# HISTORIC AND DESIGN REVIEW COMMISSION

**HDRC CASE NO:** 2024-148  
**ADDRESS:** 1231 S ALAMO ST  
**LEGAL DESCRIPTION:** NCB 750 BLK 9 LOT 8 & SW 30 FT OF 7  
**ZONING:** RM-4, H  
**CITY COUNCIL DIST.:** 1  
**DISTRICT:** King William Historic District  
**APPLICANT:** Theresa Mauricio/NEW DAY CUSTOM HOMES LLC  
**OWNER:** NEW DAY CUSTOM HOMES LLC  
**TYPE OF WORK:** Consideration of a waiver to accept and review a subsequent application under 35-608(g), new curb cut and driveway installation  
**APPLICATION RECEIVED:** March 13, 2024  
**60-DAY REVIEW:** May 12, 2024  
**CASE MANAGER:** Rachel Rettaliata

1. The applicant is requesting consideration and approval of a waiver pursuant to City Code Section 35-608(g) to accept the application submitted for the request to install a new curb cut and driveway off of S Alamo.
2. Should the waiver be granted, the applicant is requesting a Certificate of Appropriateness for approval to install a new curb cut and driveway off of S Alamo.

SITE PLAN LAYOUT

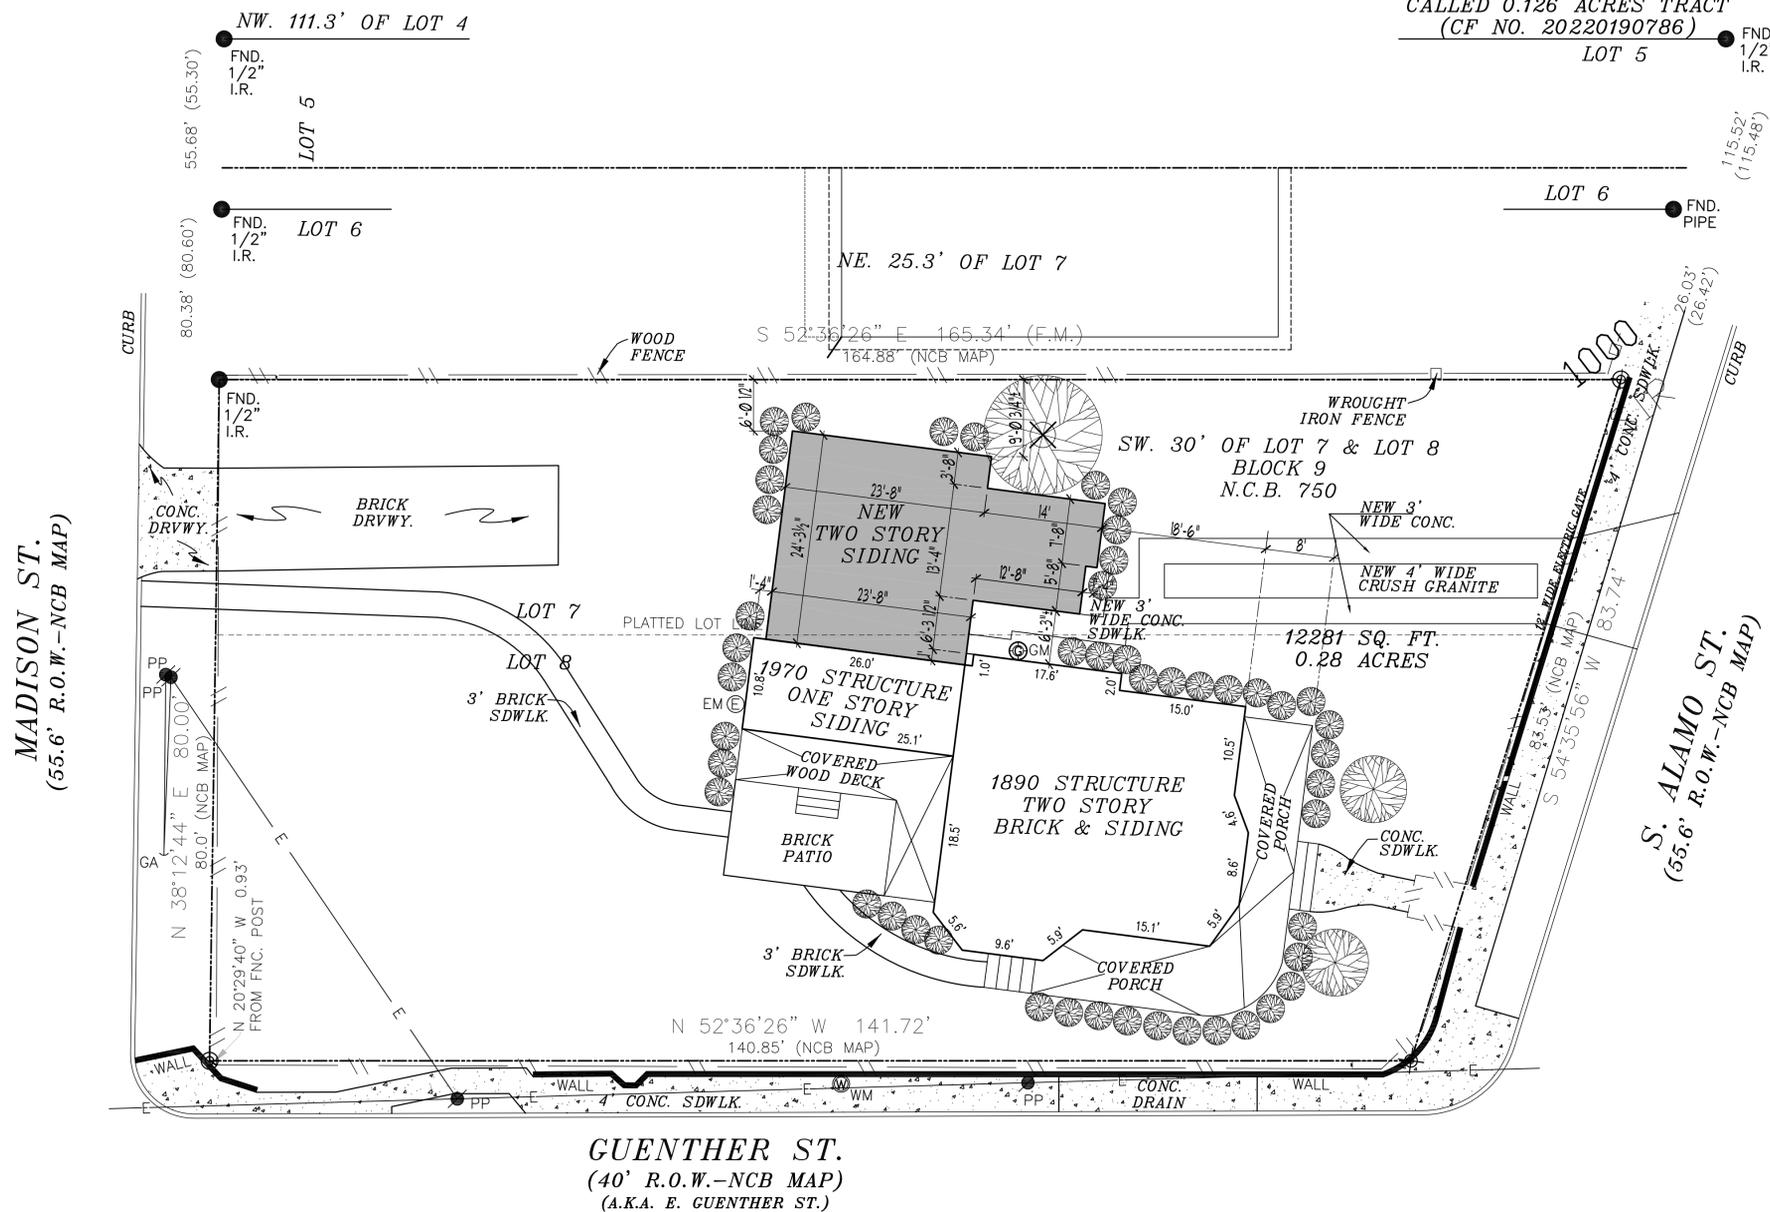
- d. **DRIVEWAY & CURB CUT** – The applicant has proposed to install a new 17-foot-wide curb cut on the east side of the property along S Alamo Street with a 10-foot-wide concrete ribbon driveway and a connected 3-foot-wide concrete walkway to the front entry of the side addition. The proposed ribbon driveway will feature 3-foot-wide concrete ribbons and a 4-foot-wide center of crushed granite. Guideline 5.B.ii for Site Elements states that applicants should avoid introducing new curb cuts where not historically found. Guideline 5.B.i for Site Elements states that driveways should not exceed 10 feet in width. The property currently features a rear driveway and curb cut on Madison Street, which is likely where the driveway was historically located and is common for historic corner lots. Staff finds the proposal inconsistent with the Guidelines. If the rear driveway is no longer accessible due to the subdivision of the lot, staff finds that the applicant should explore more appropriate driveway locations, such as off of Guenther Street. Additionally, any new driveway should not exceed 10 feet in width and the driveway apron should not exceed 12 feet in width.

Should the HDRC approve the waiver to reconsider the original application, staff does not recommend approval of the installation of a new curb cut and driveway on S Alamo Street based on finding d. Staff recommends that the applicant explores alternative driveway locations that do not result in front yard parking.

- i. That the driveway does not exceed 10 feet in width and that the driveway apron does not exceed 12 feet in width based on finding d. The applicant is required to submit an updated measured site plan and material specifications

for the proposed crushed granite to staff for review and approval prior to the issuance of a Certificate of Appropriateness.
